**ZONING AMENDMENT
& SUBDIVISION STAFF REPORT**

Date: July 21, 2011

Gulf Coast Federal Credit Union

Gulf Coast Federal Credit Union Commercial Subdivision,
Resubdivision of

SITE PLAN

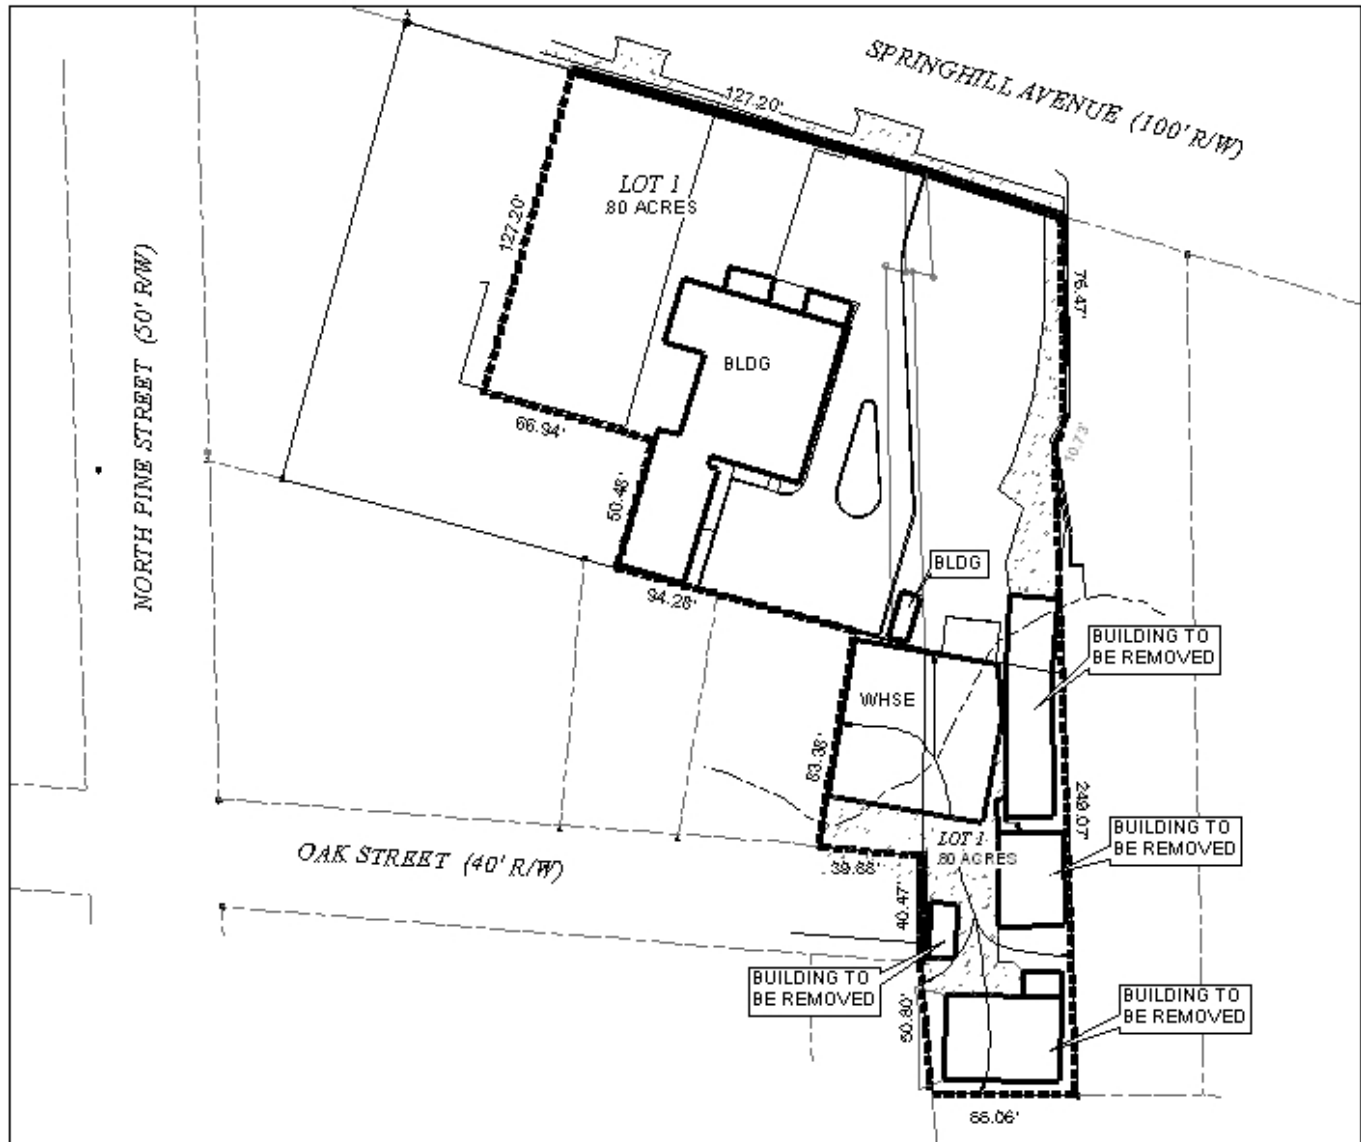
The proposed Lot 1 fronts Springhill Avenue, a planned major street as shown on the Major Street Plan Component of the Comprehensive Plan, to the North. Springhill Avenue is depicted with an adequate 100-foot right-of-way, and, as such, no further dedication should be required. The proposed Lot 2 fronts Oak Street, a minor street provided with curb and gutter. Oak Street is depicted on the plat with a 40-foot right-of-way. Section V.B.14. of the Subdivision Regulations requires a minimum right-of-way width of 50 feet, further, Oak Street is a closed-end street, and, as such, the Subdivision Regulations also require a 120-foot diameter turnaround to be dedicated and constructed. There is not enough area on the applicant's property to construct the required turnaround and any turnaround construction would negatively impact the existing building on the site. Additionally, as the site is located at the end of Oak Street, dedication would not provide any useful additional area, since any dedication would be in the area where the turnaround should be constructed. As such, a waiver of Section V.B.14. regarding right-of-way widths for Oak Street may be appropriate.

Currently, the proposed Lot 1 is developed with two curb cuts. Because Springhill Avenue is a major street and a State Highway, access management is a concern. As such, the lot should be limited to the existing two curb cuts, with the size, design, and exact location of the curb cut to be approved by Traffic Engineering and ALDOT, and conform to AASHTO standards.

The proposed Lot 2 has frontage at the terminus of Oak Street. The proposed site plan submitted with the rezoning request illustrates two curb cuts for Lot 2 to Oak Street, one to accommodate an existing bay door for the warehouse on the site and the other would basically terminate the public street into the site's parking lot. This situation is not ideal. A more preferable situation would be to allow the curb cut to Oak Street to accommodate the existing roll up door and to have the applicant construct a "T-shaped" turnaround for the Fire Department and have parking provided on Lot 1 of this subdivision. This would require a Planned Unit Development application to allow the shared access and parking between the two lots, however, both lots have the same owner, so this should not be a problem. As such, the proposed Lot 2 should be limited to two curb cuts, one for the existing bay door on the warehouse, and the other for a dedicated "T-shaped" turnaround, with no parking allowed in that area. Additionally, approval of a Planned Unit Development should be required prior to signing of the Final Plat, if approved.

The lot area sizes are shown in acres, and these should be revised to show the lot area size in square feet on the Final Plat, if approved. Also, both of the proposed lots are either zoned B-4, or proposed to be zoned B-4, which do not require a front setback. As such, Section V.D.9. of the Subdivision Regulations regarding the 25-foot front setback could be waived, however, a note should be placed on the Final Plat that if either Lot is ever rezoned to a classification other than B-4, General Business District, then the required front yard for that zoning district shall be the required front yard.

The plat illustrates the proposed 1.1 acre \pm , 2-lot subdivision. The applicant states that the subdivision is served by both public water and sanitary sewer.

The proposed lots, as depicted, meets the minimum size and frontage requirements as regulated by the Subdivision Regulations.

- 3) compliance with all applicable building and fire code requirements regarding firewall separations for existing buildings;
- 4) placement of a note on the Final Plat stating that Lot 1 is limited to the two existing curb cuts to Springhill Avenue, with the size, design, and exact location of the curb cut to be approved by Traffic Engineering and ALDOT and conform to AASHTO standards;

- 5) placement of a note on the Final Plat stating that the Lot 2 is limited to two curb cuts to Oak Street, one to accommodate the existing bay door of the warehouse, and the other to accommodate a T-shaped turnaround at the terminus of Oak Street, with the size, design, and exact location of the curb cut to be approved by Traffic Engineering and conform to AASHTO standards;

- 6) construction of a T-shaped turnaround at the terminus of Oak Street, with no parking allowed in the turnaround;
- 7) revision of the lot area size to be shown in square feet, on the Final Plat;

- 8) placement of a note on the Final Plat stating that if either Lot is ever rezoned to a classification other than B-4, General Business District, then the required front yard for that zoning district shall be the required front yard;
